DEVELOPMENT REVIEW COMMITTEE (DRC) COMMENT REPORT

PROJECT NAME: Riverbend Townhouses

CASE NUMBER: R18013

REQUEST: Site Plan Level II Review: 8 Residential
Townhouse Units

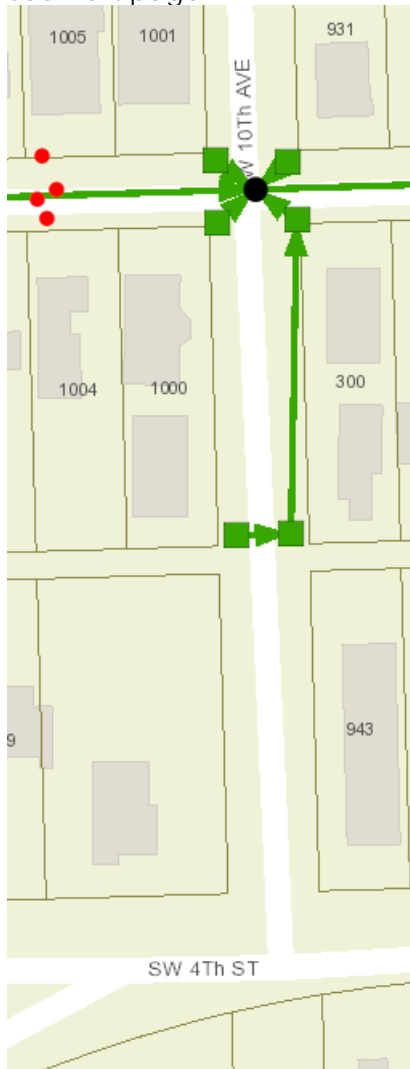
The City GIS shows stormwater is managed by grassed swales adjacent to the proposed development as shown in the map provided at the end of this report. The following comments pertain to possible impacts of the proposed development and/or construction activities to the existing condition of the City's stormwater assets. The applicant shall provide an itemized response letter addressing the following comments:

1. Please provide (or revise if already submitted) an erosion, sedimentation, and stormwater pollution prevention plan (**SWPPP**) showing the adjacent City's existing stormwater system as shown in the survey and to the limits shown with green line work in the storm map provided at the end of this report. A copy of the approved SWPP shall be at the construction site from the date of demolition initiation to the date of final construction activities.

- a) Contractor shall provide CCTV videotapes to City STW OPS of the existing stormwater system to the limits shown with green line work in the storm map provided at the end of this report in order to document the PRE and POST construction conditions of the City's storm system.
